AGENDA  
 PEACH BOTTOM ATOMIC POWER STATION, UNITS 2 AND 3  
 LICENSE RENEWAL APPLICATION  
 MONDAY, OCTOBER 22, 2001

**PURPOSE:** To provide Exelon an opportunity to clarify the scoping and screening methodology, particularly as it relates to the use of system "realignment" to determine components within the scope of renewal. The NRC staff expects to understand how this process fulfills the requirements of §54.4 in sufficient detail to complete the review of the system scoping results and the methodology.

License Renewal Application  
Scoping and Screening  
Methodology meeting

October 22, 2001

Figure 2.1-1 - Scoping and Screening Process Overview

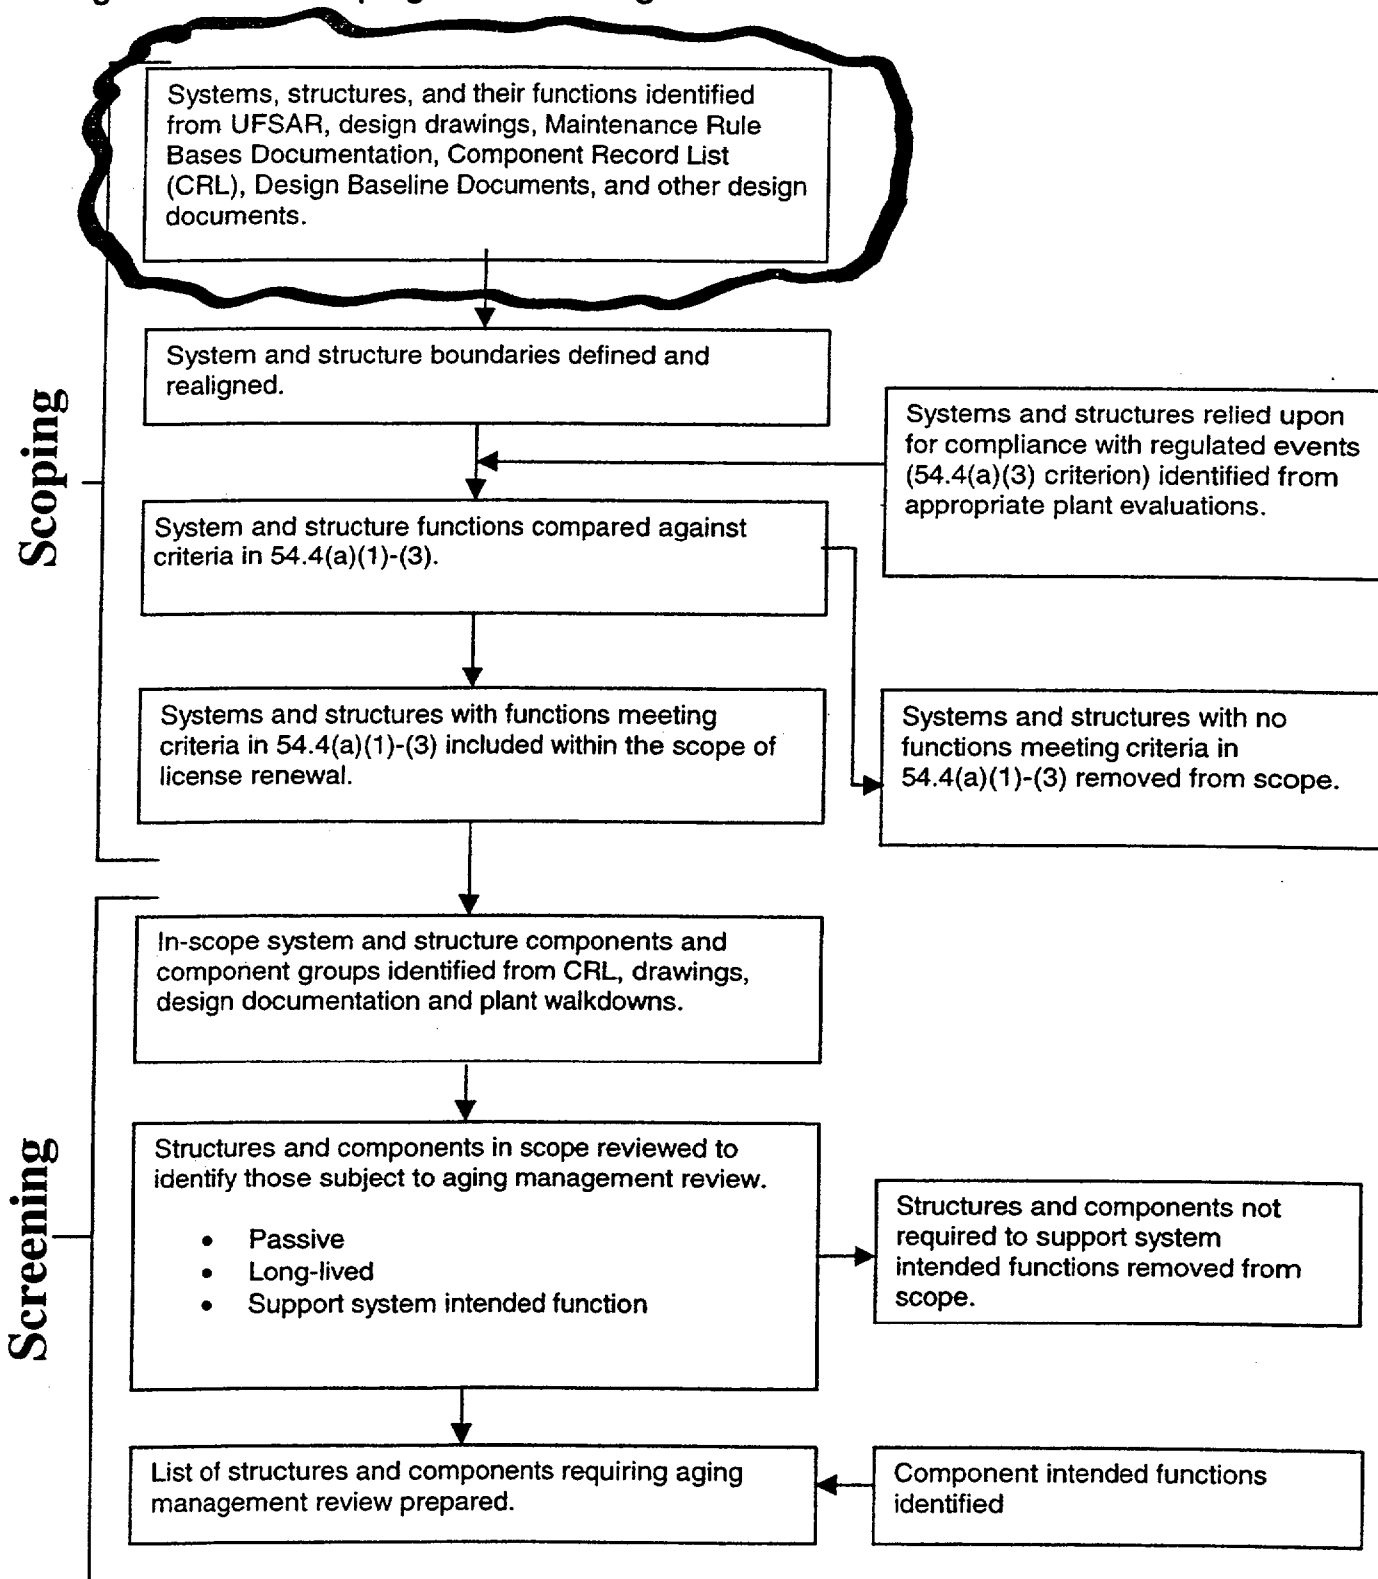
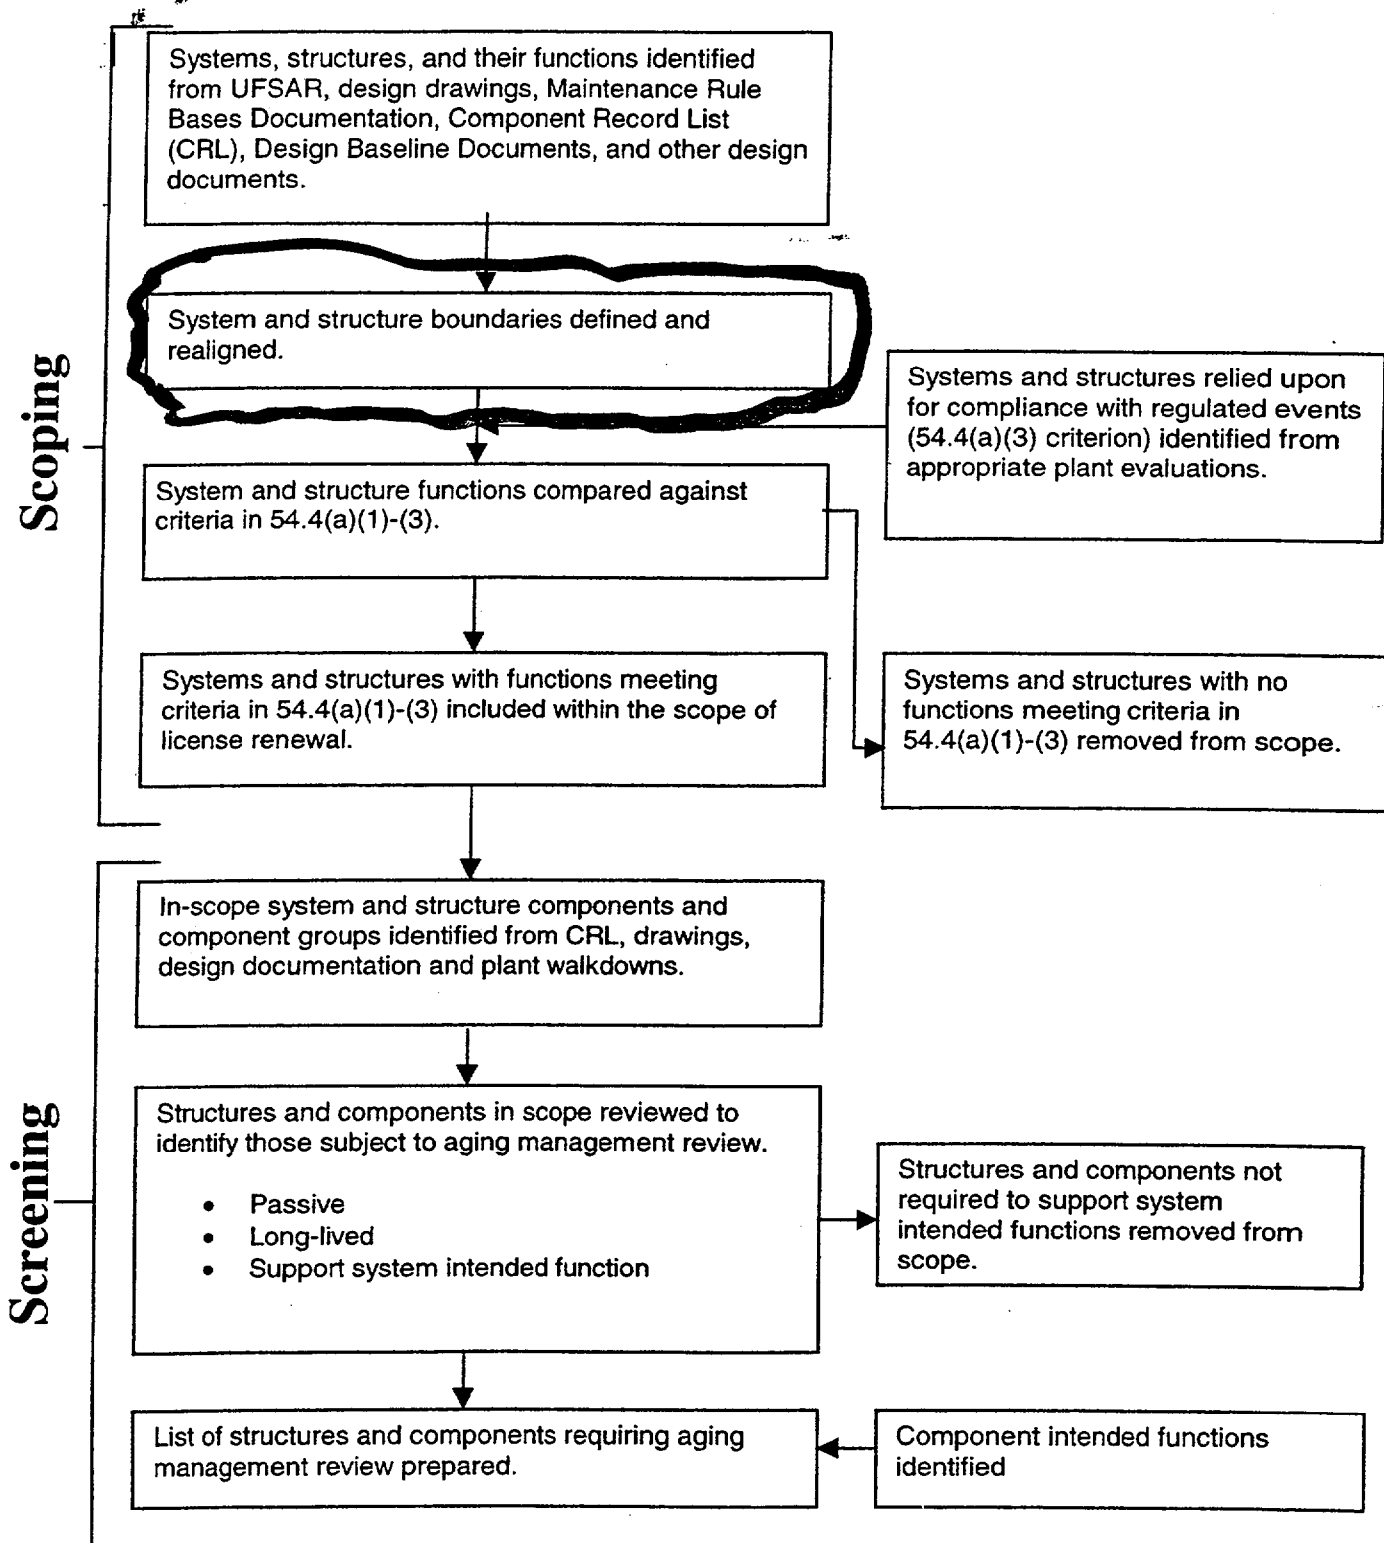
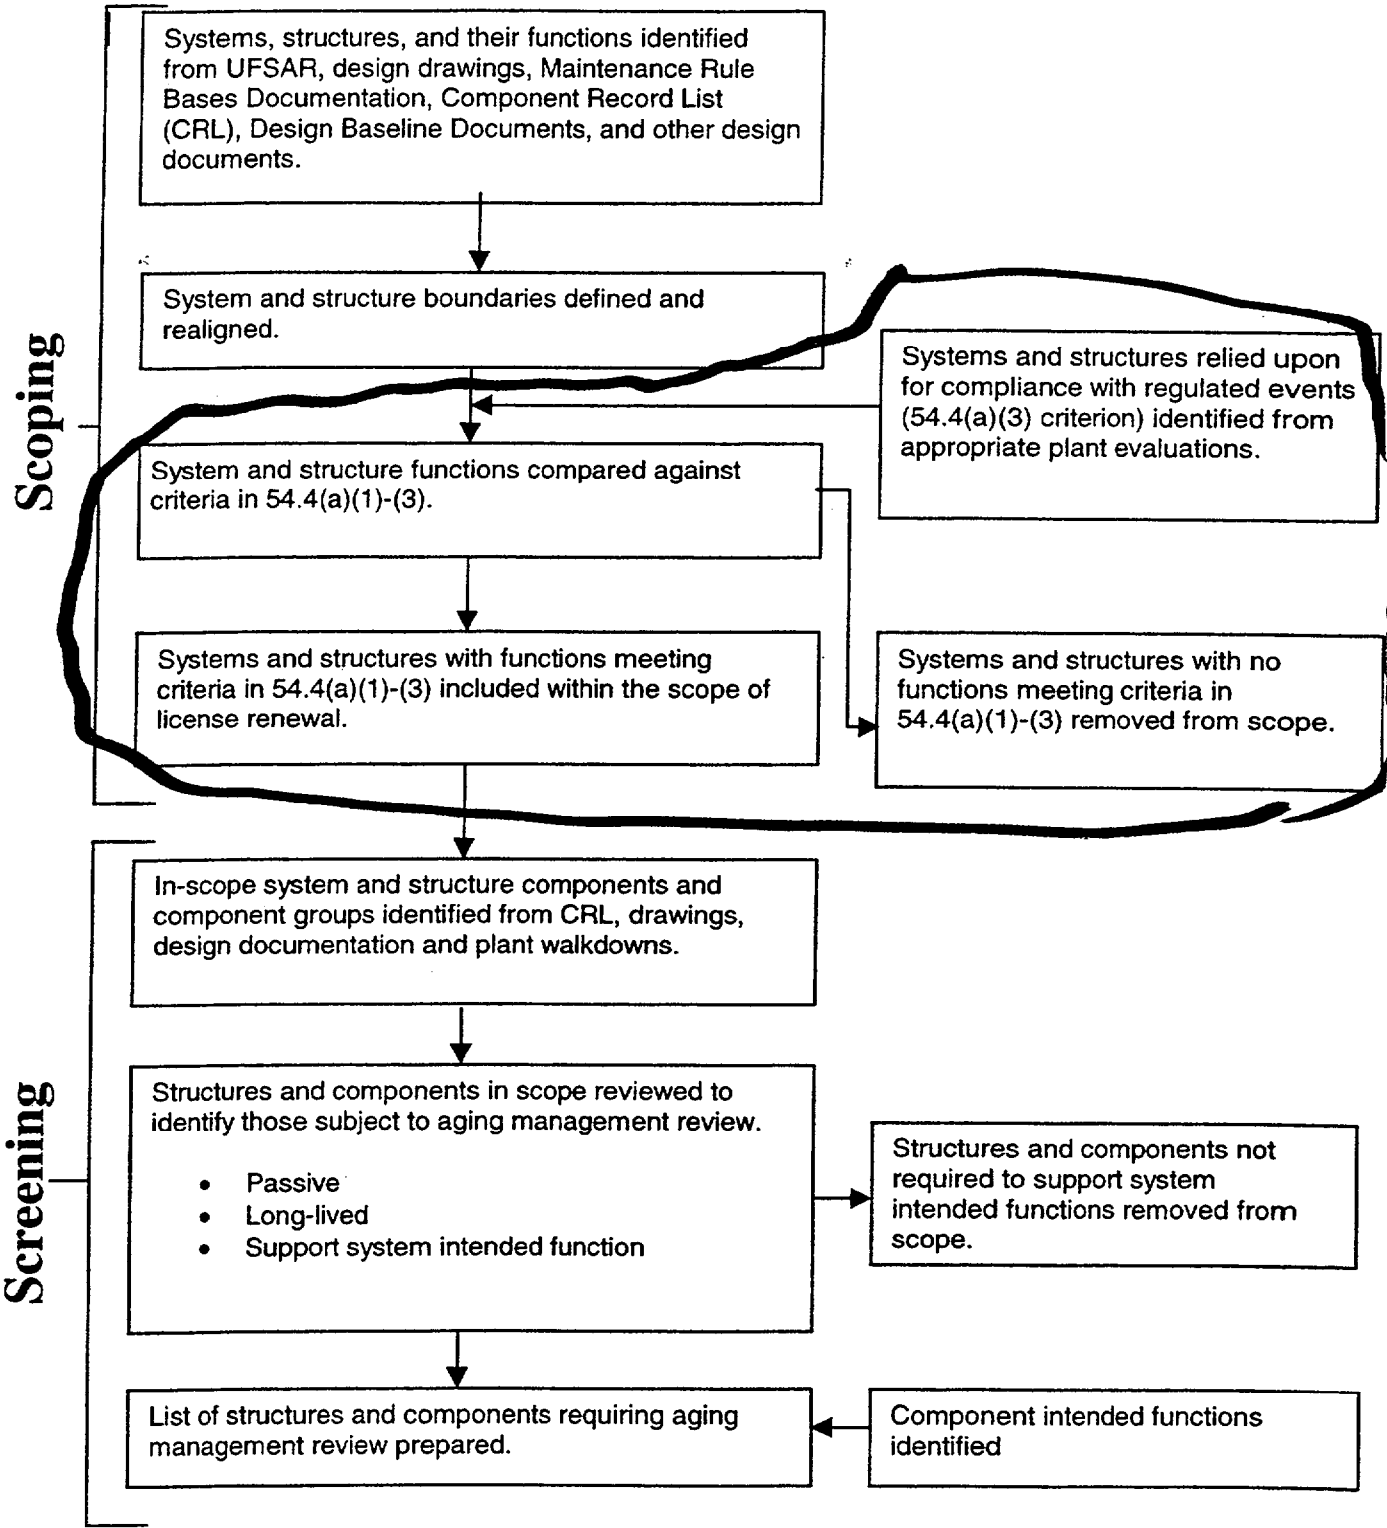
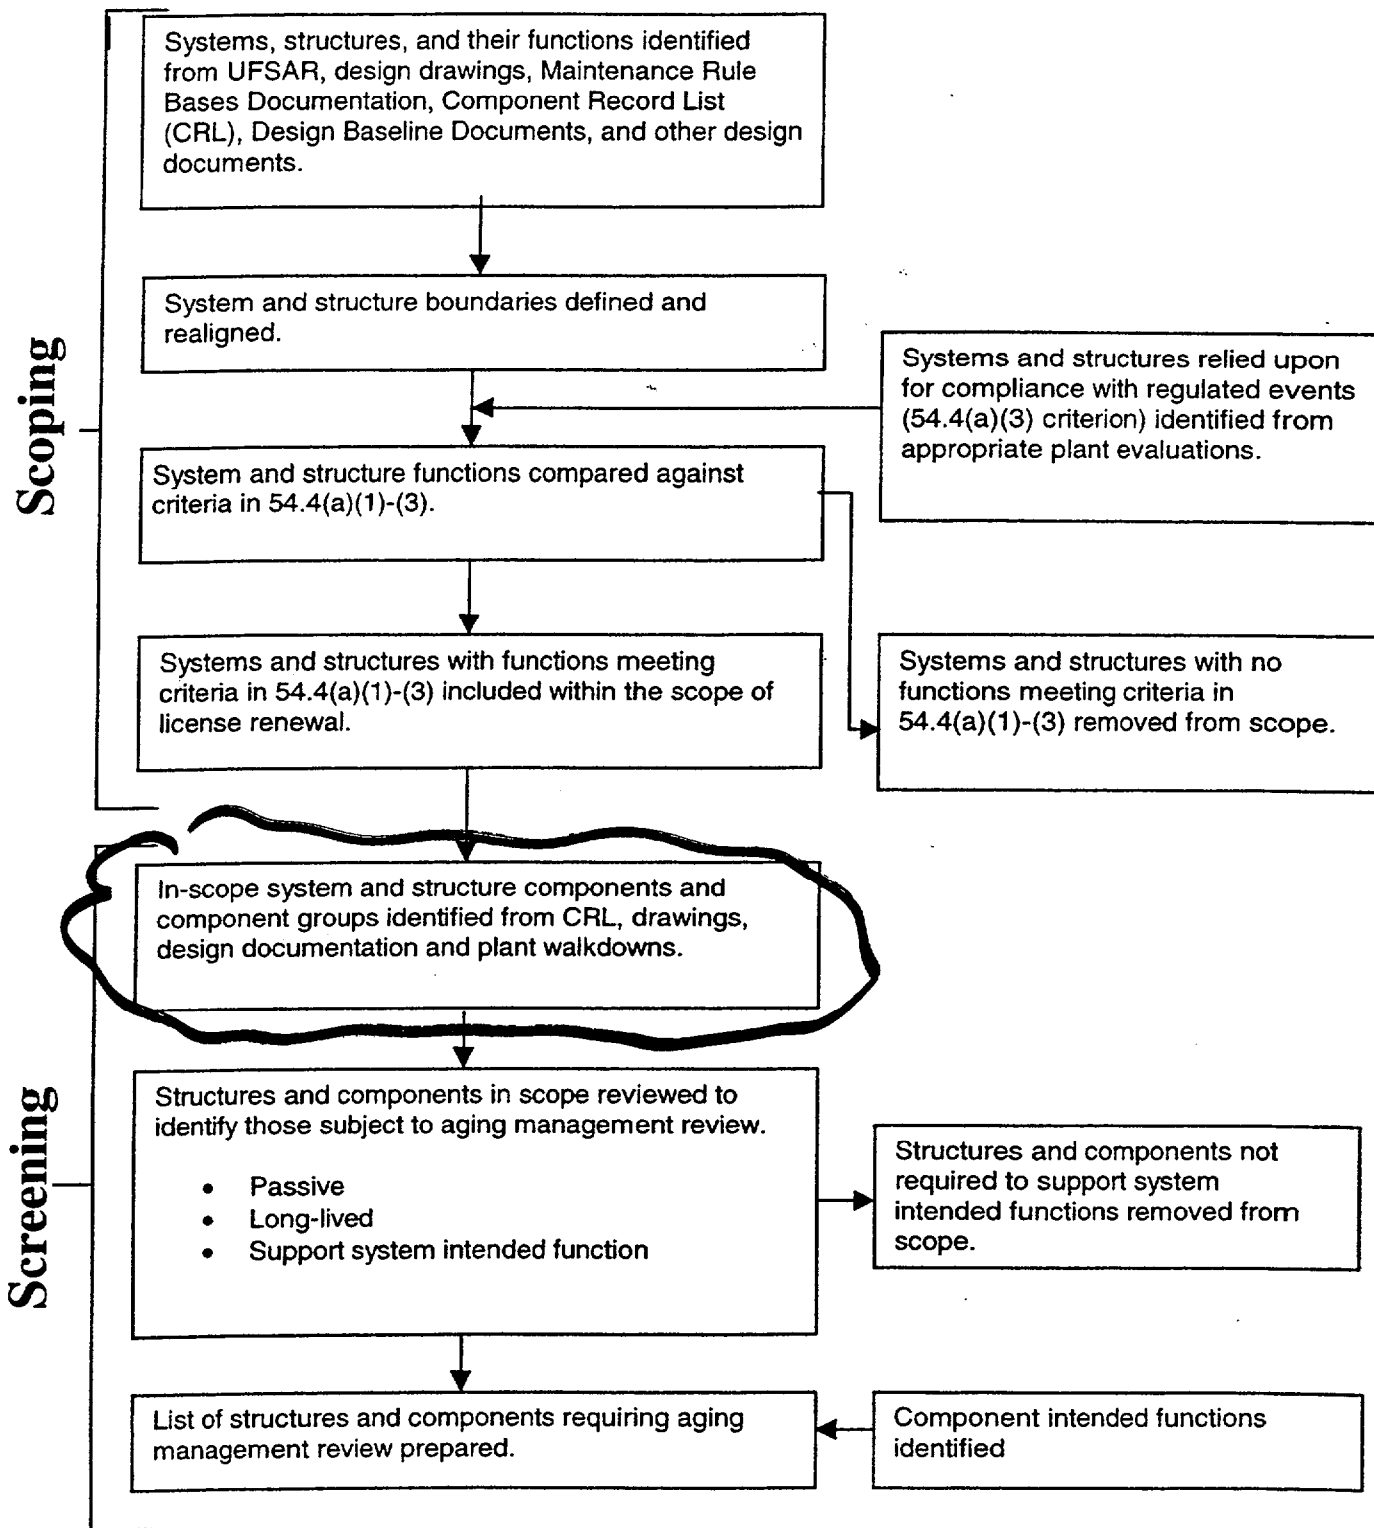
1	Introduction : Define the issues and expected outcome of the meeting.	NRC	9:00am
2	Clarify the scoping and screening process as shown in figure 2.1-1 of the PBLRA, as discussed at the meeting on 9/24/01, and explain how Exelon concluded that this process meets the requirements of 10 CFR 54.4 with respect to the following: <ul style="list-style-type: none"> <li>• System intended functions.</li> <li>• Explain the system realignment process and the rational for its use.</li> <li>• Determination of system/structure boundaries.</li> <li>• How the systems, structures and components reflected in the Peach Bottom current licensing basis [as defined by §54.3(a)] are captured in a consistent manner in the scoping process.</li> <li>• Explain the differences between the Component Record List and the UFSAR and how they are treated by the scoping process and reflected in the LRA.</li> </ul>	Exelon	9.15am

-Break-		10:45am
3	Discussion of NRC examples of apparent scoping inconsistencies and LRA clarity that could hamper the transparency of the review process: <ul style="list-style-type: none"> <li>• Reactor Water Cleanup (RWCU) System example is not in-scope (Fig 2.1-1 vs §54.4) but SCs of RWCU are in-scope per §54.21.</li> <li>• Given that system boundaries have been realigned for the PB LRA, how can the staff efficiently determine that all SCs are included in the Component Groups defined by the PBLRA?</li> </ul>	NRC	11:00am
	-Lunch-		12:00pm
4	Exelon to provide explanation for the specific examples in item 3 as to how the scoping and screening process was performed to ensure that SCs that need to be in scope of license renewal are captured in a consistent manner, in accordance with Part 54.	Exelon	1:00pm

- A comprehensive list of systems and structures to be evaluated for license renewal scoping was produced from the above documentation sources (LRA page 2-2, Section 2.1.2.1, first paragraph). These information sources are consistent with NUREG-1800 Standard Review Plan for License Renewal Table 2.1-1, and also Table 3.1-1 of NEI 95-10 revision 3, endorsed by Regulatory Guide 1.188:

- Component listings were downloaded from the CRL for each system.
- Component listings were used to mark-up P&ID drawings to establish in-scope system boundaries (LRA page 2-5).
- Some non-safety related systems at PBAPS include safety related components. For example, isolation valves in the makeup water fill connection to the safety related High Pressure Service Water (HPSW) system are safety related because they are part of the HPSW boundary. The makeup water connection is from the Water Treatment System, which is not safety related, but these individual isolation valves are safety related. Other examples are described on page 2-5 of the LRA, under the sub-heading of System Boundary Realignment.

- This is a general overview of the process of addressing the license renewal scoping criteria, which is described in detail in LRA pages 2-6 through 2-10.
- For systems, evaluation against criteria 54.4(a)(1) and (2) is based on Maintenance Rule program scoping documentation (LRA page 2-6 and 2-7).
- For structures, evaluation against criteria 54.4(a)(1) and (2) is based on review of UFSAR seismic classification (LRA pages 2-6 through 2-8).
- For systems and structures, evaluation against criteria 54.4(a)(3) is based on review of appropriate plant evaluations for the regulated events (page 2-9 and 2-10). License renewal position papers were prepared to identify specific systems credited for 10 CRF 50.48 (Fire Protection) and for 10 CFR 50.63 (Station Blackout).
- ATWS systems determined from CRL ATWS data field.

- Screening Methodology described in LRA Section 2.1.3, page 2-12 through 2-14.
- Final listing of in-scope components identified from previously downloaded component listings.
- Components entered into a License Renewal Database.
- Additional components not included in the CRL were identified and added to the database.

- Screening Methodology described in LRA Section 2.1.3, page 2-12 through 2-14.
- Component active versus passive determinations made in accordance with 10 CFR 54.21(a)(1)(i) and the guidance of NEI 95-10.
- Long-lived components identified in accordance with 10 CFR 54.21(a)(1)(ii) and the guidance of NEI 95-10.
- During this detailed component level review, any additional components identified that are not required to support a system intended function are removed from the scope of license renewal. Component listings (the license renewal database) and boundary drawings were updated as required.
- Intended functions identified for the structures and components requiring aging management review.
